SUBJECT: DRAFT SAFETY EVALUATION FOR BABCOCK & WILCOX MPOWER  
TOPICAL REPORT R0003-08-002089, REVISION 3, "INSTRUMENT  
SETPOINT METHODOLOGY TOPICAL REPORT" (TAC NO. RN6113)

DRAFT SAFETY EVALUATION REPORT FOR BABCOCK & WILCOX COMPANY TOPICAL  
REPORT R0003-08-002089, REVISION 3, "INSTRUMENT SETPOINT  
METHODOLOGY TOPICAL REPORT" (TAC NO. RN6113)  
PROJECT NO. 0776

Figure 5.1: Setpoint Relationships – For increasing Setpoint (Similar for decreasing setpoint, but process is decreasing towards the setpoint).

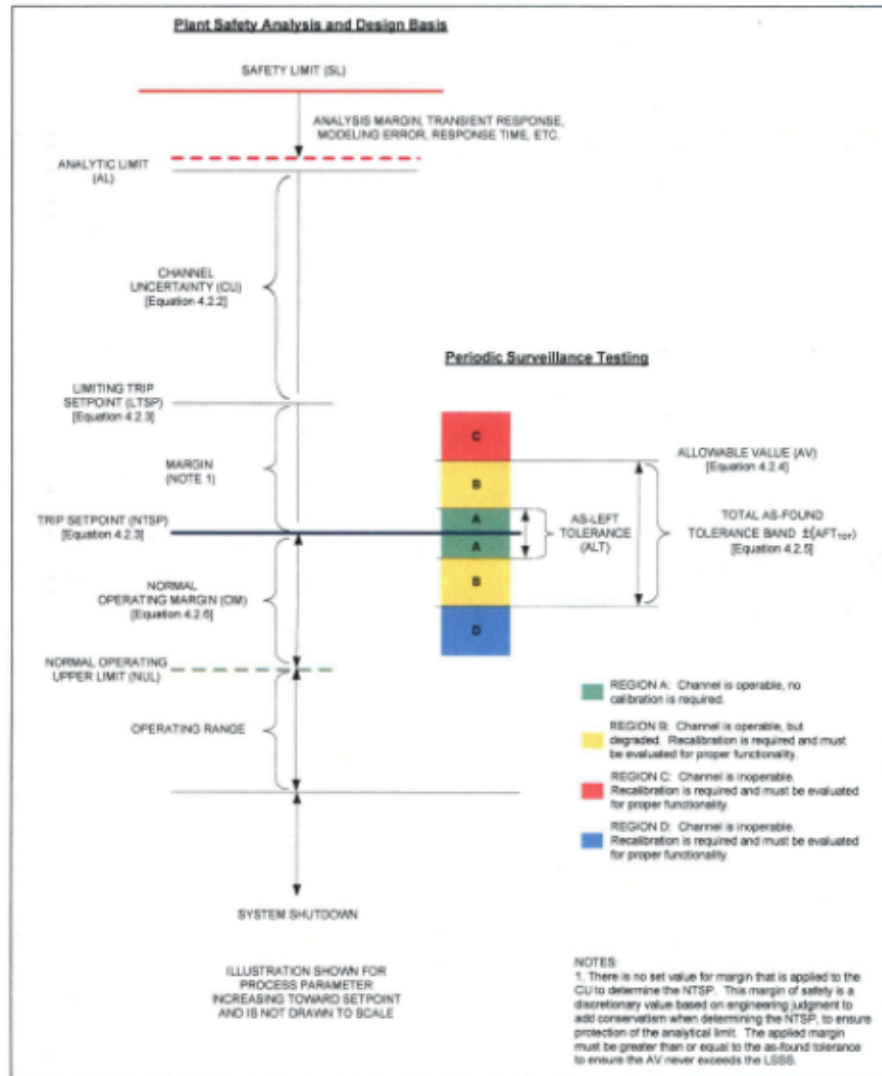
In the B&W methodology, the AL is established to ensure that a trip occurs before the SL is reached. The purpose of an LSSS is to assure that a protective action is initiated before the process conditions reach the AL. Trip setpoints are chosen based on the LSSS and to minimize spurious trips close to the normal operating point of the process. Figure 5.1 of the TR shown below provides a pictorial of the B&W setpoint methodology relationships.

As presented in the B&W setpoint methodology Sections 4.1.5 and 4.2.3, the applicant defines LTSP as an LSSS and also defines NTSP as the desired value of the measured variable at which an actuation occurs. The calculation of the LTSP value is set forth in Section 4.2.3 as  $LTSP = AL \pm CU$ , where CU is the total channel uncertainty. In Note 1 on Figure 5.1, the applicant defines AV such that it will never exceed the LTSP (LSSS) and in most cases should be more conservative than the LTSP. The calculation of the AV is set forth in Section 4.2.4 as  $AV = NTSP \pm AFT_{TOT}$  where  $AFT_{TOT}$  is the total AFT for the entire instrument chain. The NTSP includes additional margin such that it is more conservative than the LTSP. In Section 4.2.5 the applicant defines the AFT and ALT as double sided bands around the NTSP. The applicant states that at a minimum the AFT includes reference accuracy, drift, and ALT

uncertainties. The ALT is based on accuracy of the channel calibration. The staff finds that this approach is consistent with RG 1.105, Revision 3 and ANSI/ISA-67.04.01-2000.

Based on the discussion, sample calculations, and figures presented in the TR, the staff finds that the B&W setpoint methodology demonstrates that the correct relationships between the SL, AL, AV, NTSP, LTSP, AFT, and ALT will be ensured, that the basis for the trip setpoint is correct, and that the requirements of GDC 13 and 20 are met.

NRC RIS 2006-17 detailed a concern with verification of operability using only AV or a one-sided approach during periodic testing (channel operational test, calibration test). To address this concern the B&W mPower setpoint methodology uses double-sided acceptance criteria bands. Figure 5.1 (above) and Table 4.2 (below) of the TR describe how the operability of the instrument loop is evaluated. Exceeding the AFT in either the high or low direction may indicate degraded performance and inability of the instrument channel to meet its intended function.
